PROJECT
SHERWIN WILLIAMS DECORATING CENTER

PETITION NO: Z-25

PROPOSED ZONING: LRC

ZONING DIVISION COMMENTS:

Z-25

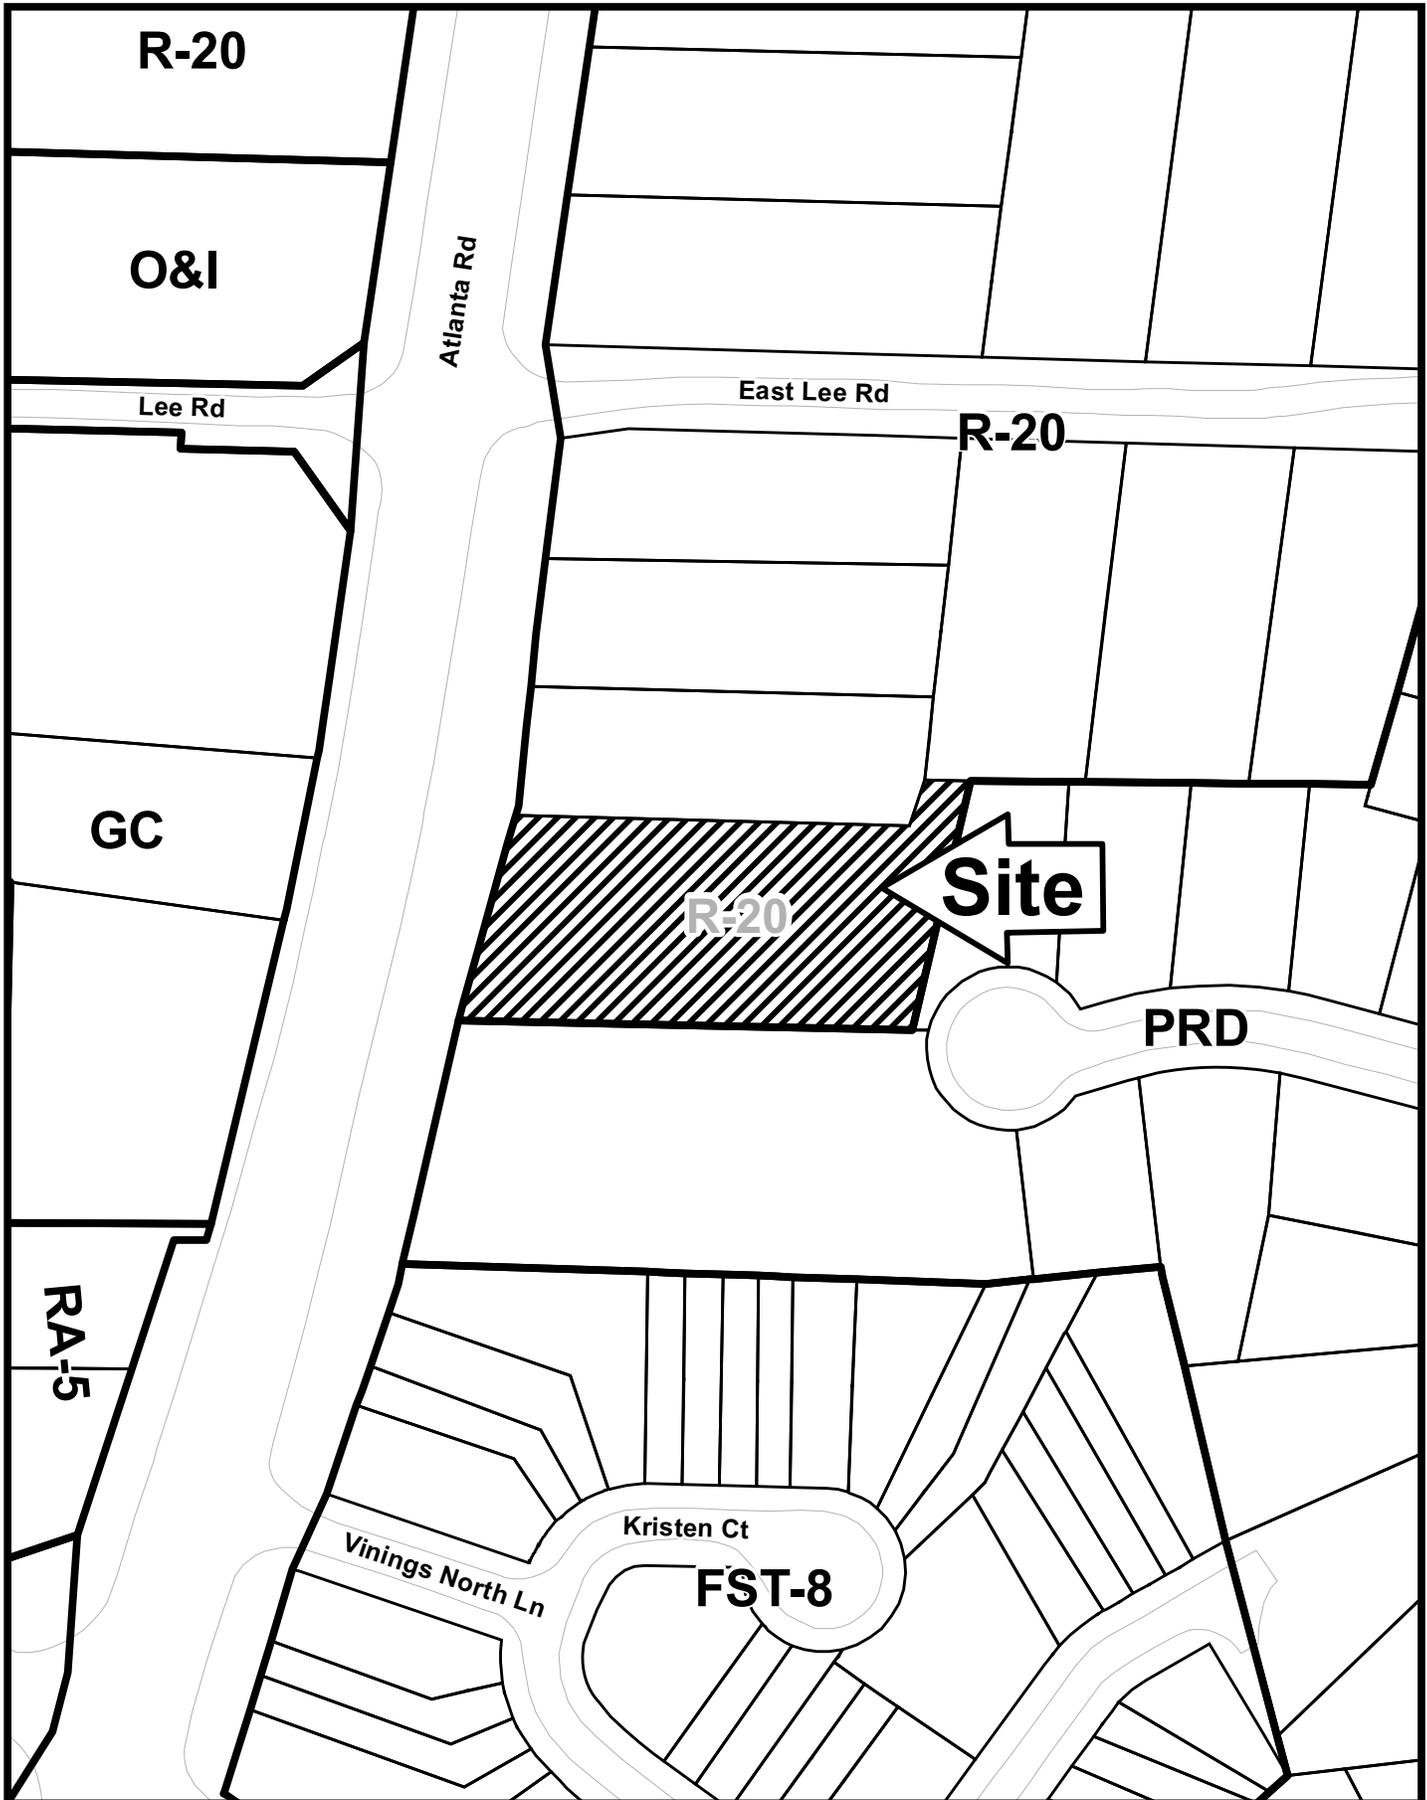
1. Reduce the required landscape buffer from 20-feet to 15-feet on the south property line, and 5-feet on the north property line;
2. Reduce the required number of parking spaces from 25 parking spaces to 15 parking spaces;
3. Increase to allowable Floor Area Ratio from 5,000 square-feet per acre to 6,250 square-feet per acre.

- No Stormwater controls shown - **must be addressed at Plan Review**
- Copy of survey is not current - Additional comments may be forthcoming when current site conditions are exposed.
- No site improvements showing on exhibit.

1. This site is naturally divided by a ridge that runs roughly north & south through the center of the parcel. The front half of the site drains to the west to the Atlanta Road R/W. The rear half of the site drains through existing residential lots to the east.
2. Since the nearest existing receiving structure to the east is located within the adjacent Paces Ferry Park S/D approximately 150 feet away and would require the acquisition of a drainage easement to access, it is anticipated that the required stormwater management facility be discharged directly to the existing system within the Atlanta Road R/W. This issue must be addressed at Plan Review.

As necessitated by this development for egress from Atlanta Road, a deceleration lane will be required at the access point.

Recommend a deceleration lane at the access point along Atlanta Road.

Recommend replacing all disturbed sidewalk, curb and gutter along the road frontage.
